FED. ROAD DIST. NO.	STATE	PROJ. NO.	FISCAL YEAR	SHEET NO.	TOTAL SHEETS
HAWAII	HAW.	I-H3-1(72)	1991	C.O. ADD. 7	521

TYPICAL ROADWAY SECTIONS
H3 KANEHOE INTERCHANGE

INTERSTATE ROUTE H-3
F.A.I. PROJ. NO. I-H3-1(72)

**TYPICAL RAMP
SECTIONS AND DETAILS**

TYPICAL SECTION AND DETAILS

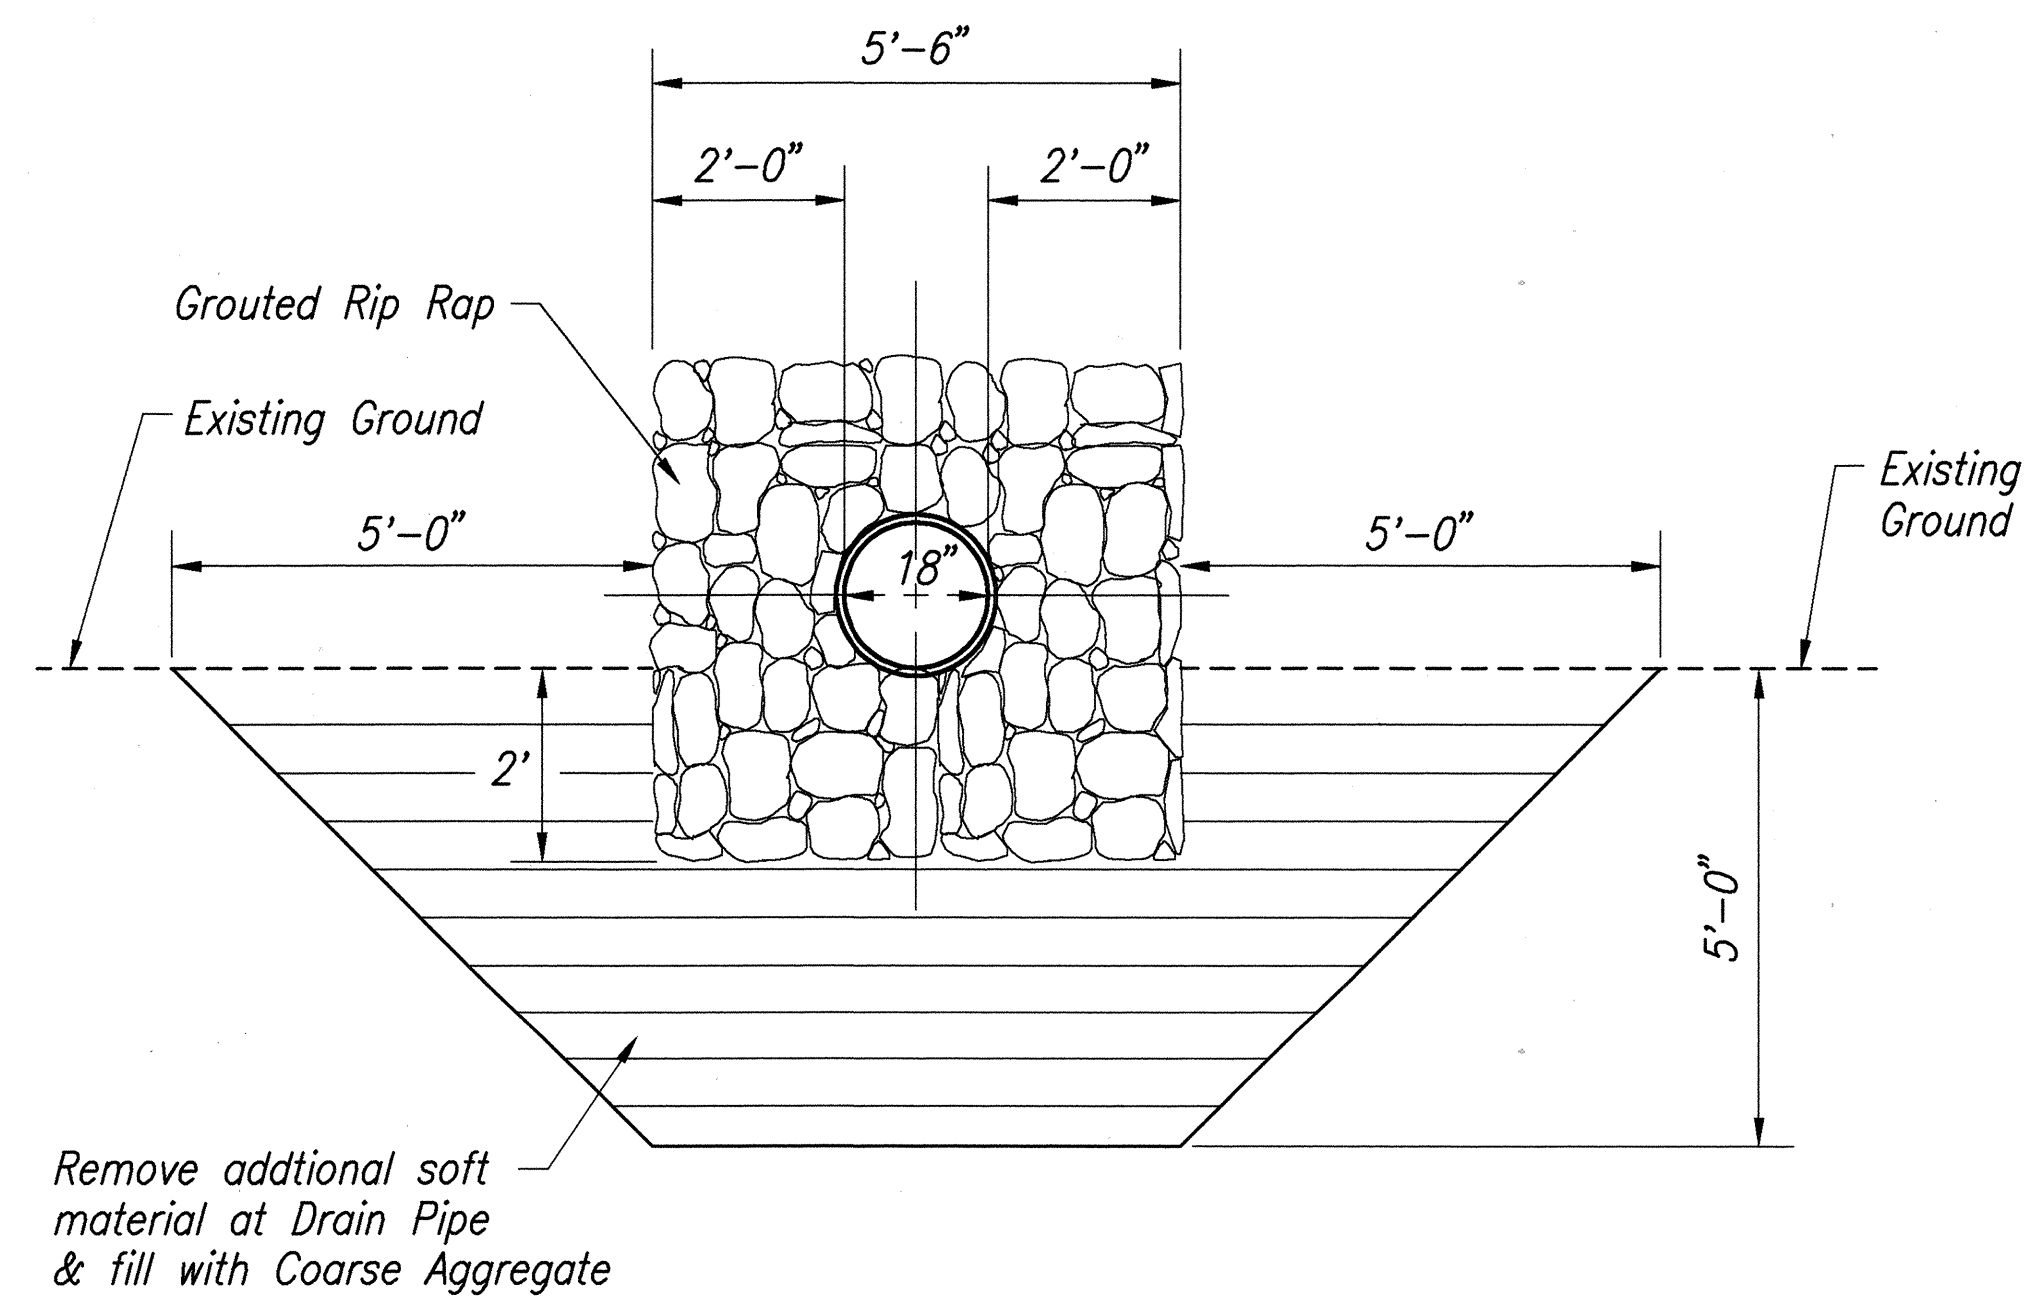
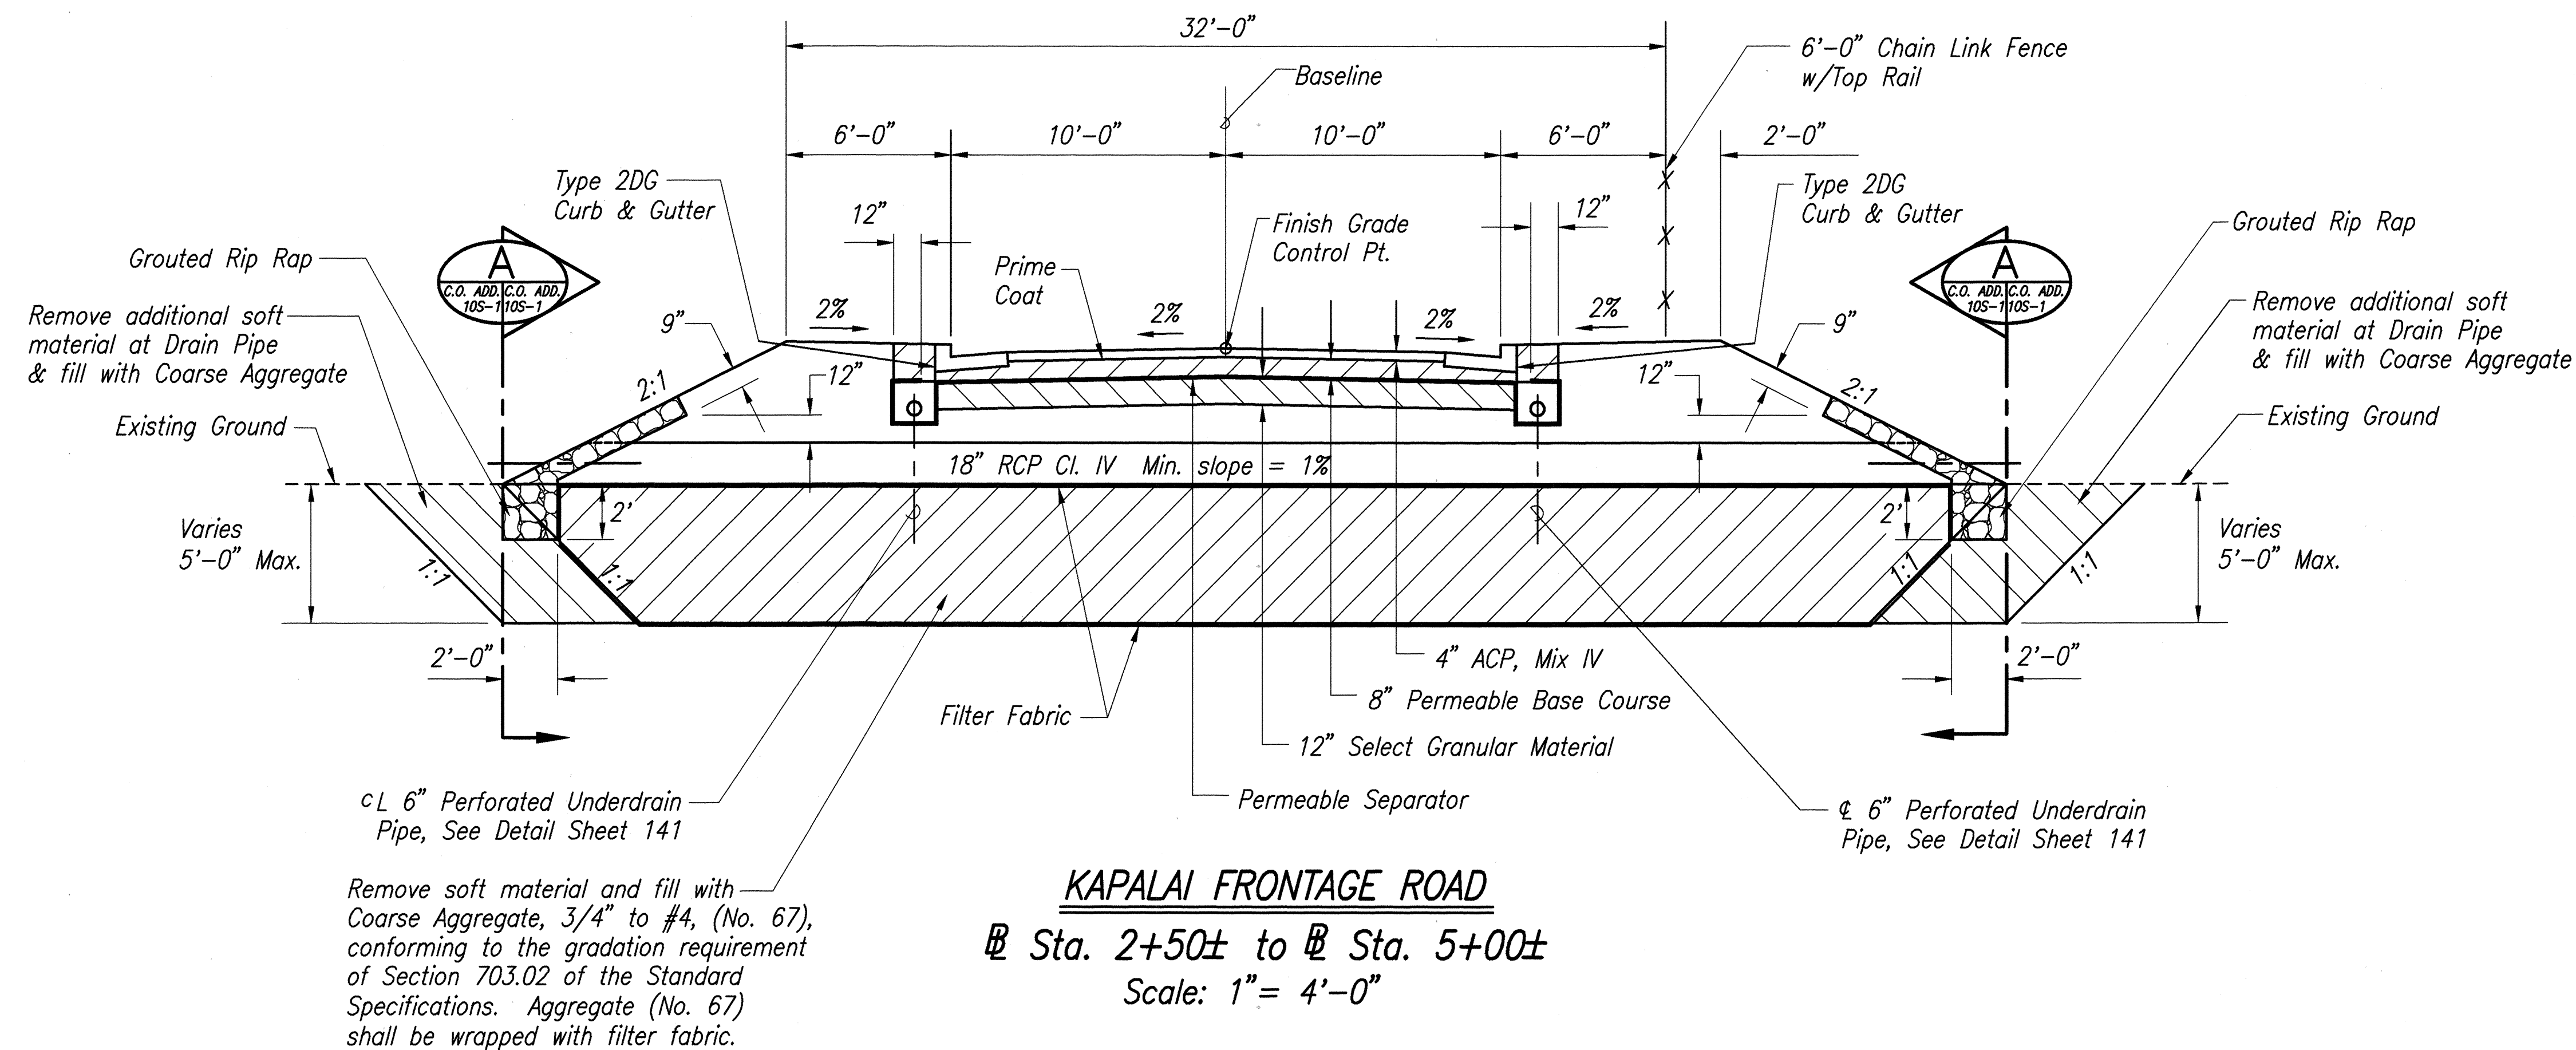
9/11/92	Sheet added to show Kapalai Frontage Road Typical Section from 2+50± to 5+00±.
DATE	REVISION

TYPICAL SECTION
LIKELIKE EMERGENCY TRUCK RAMP
 Scale: 1" = 5'-0"

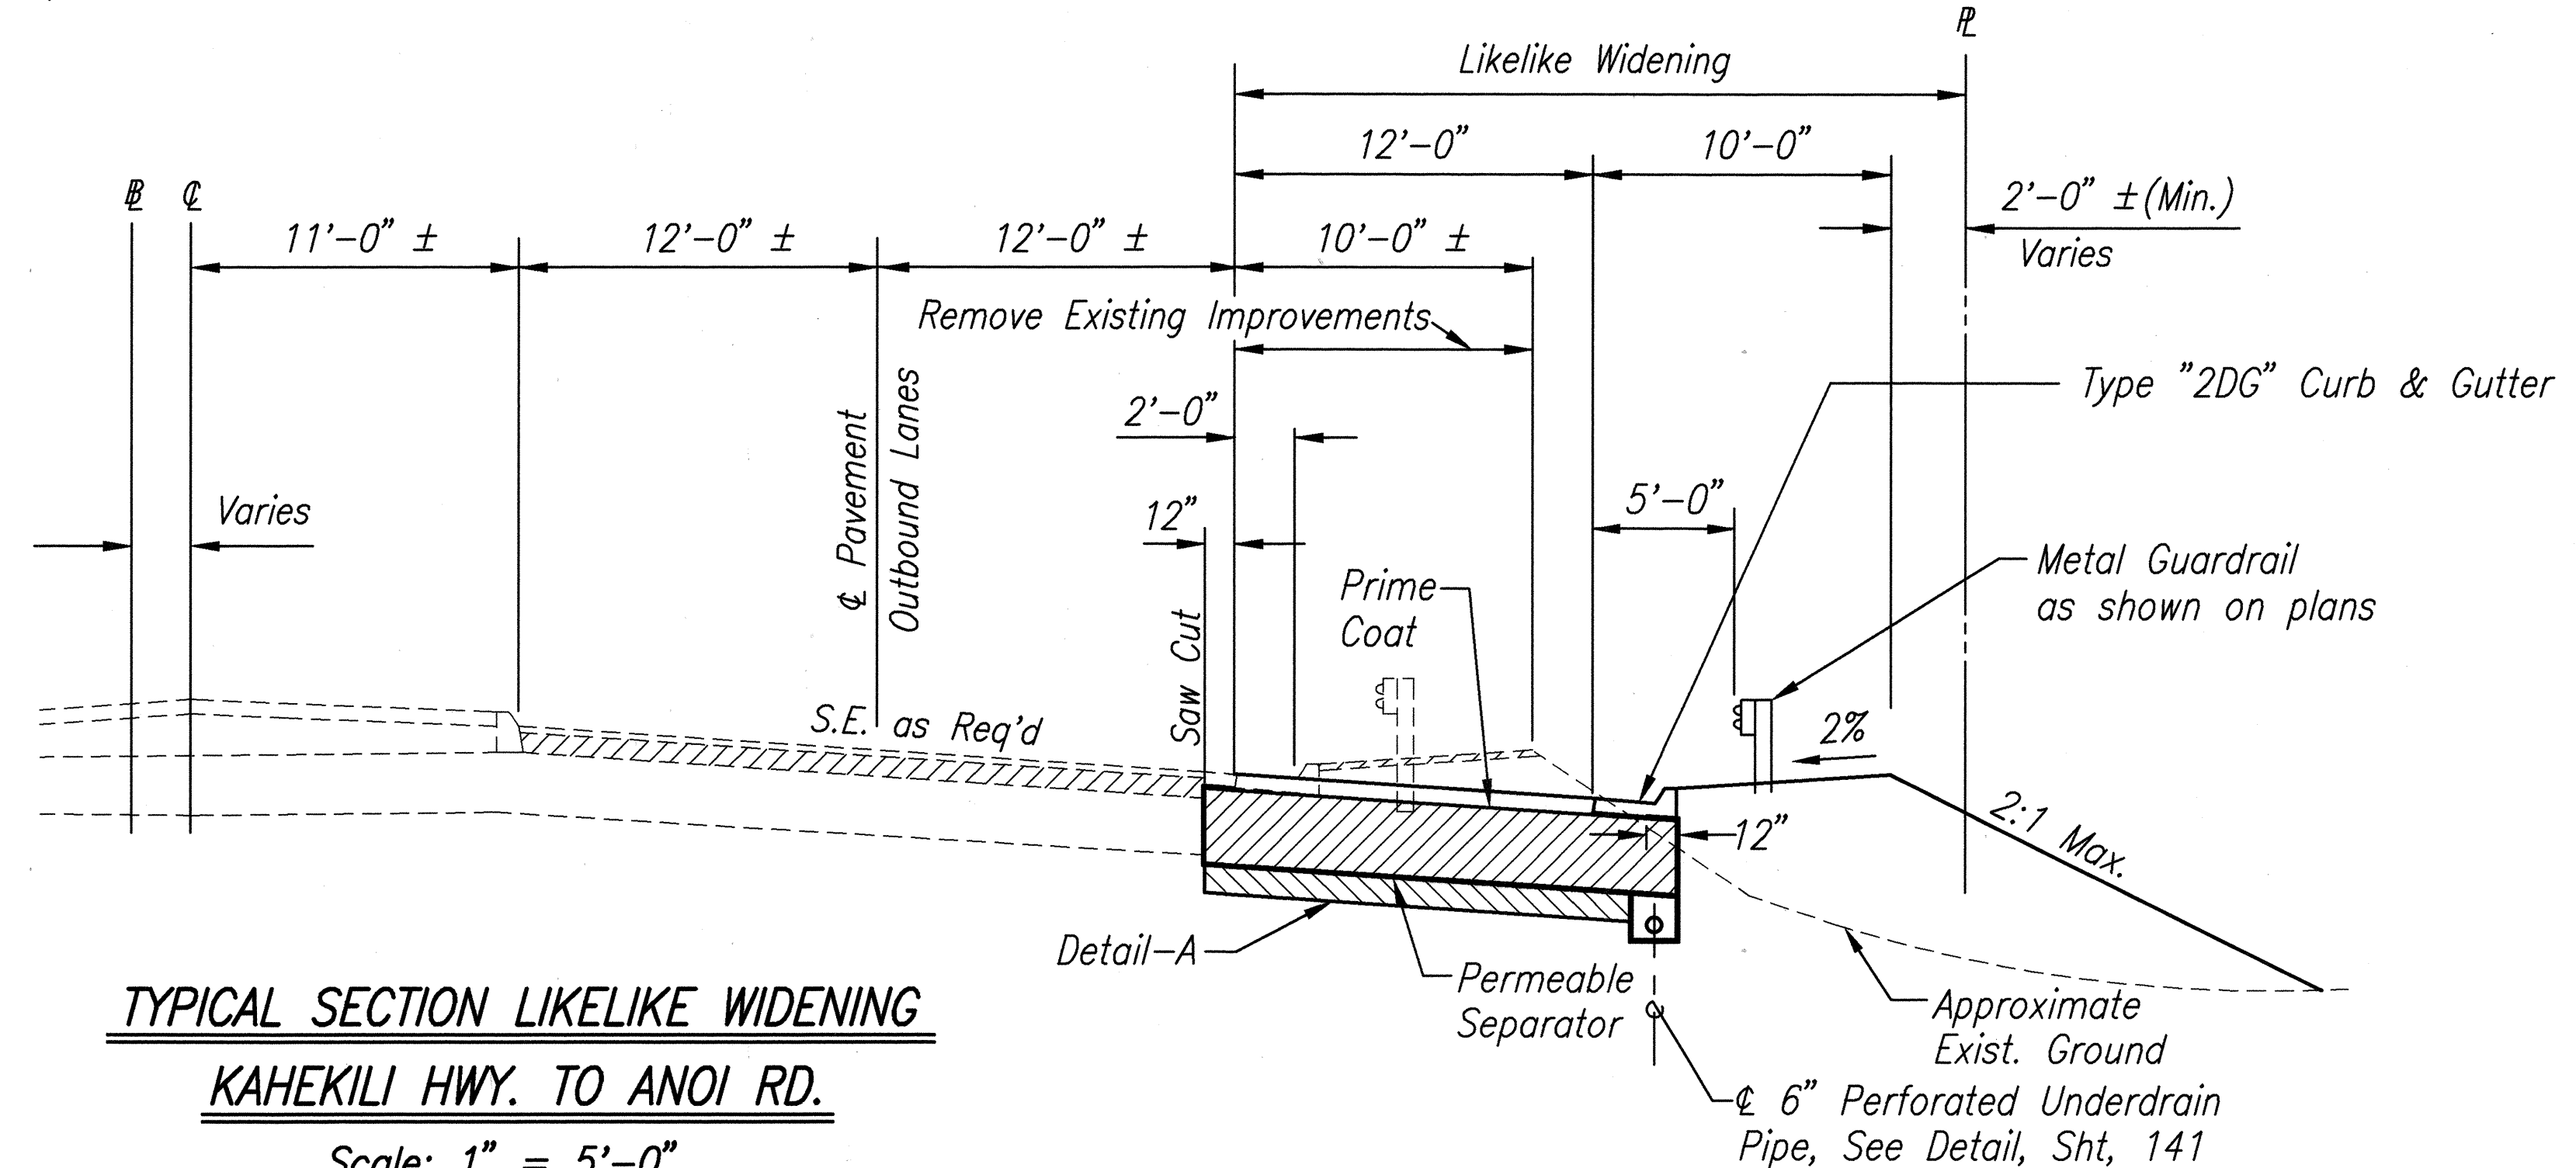
DATE	REVISION
11/9/93	Added Underdrain @ Likelike Widening
9/3/93	Extended A.C., Permeable Base Course, & Permeable Separator to Type 4G Guardrail @ Likelike Emergency Truck Ramp.
1/7/93	Added Underdrain at W.E.E.R.
2/14/92	Replaced Metal Guardrail along Likelike Emer. Escape Ramp with Type 4G Concrete Guardrail.
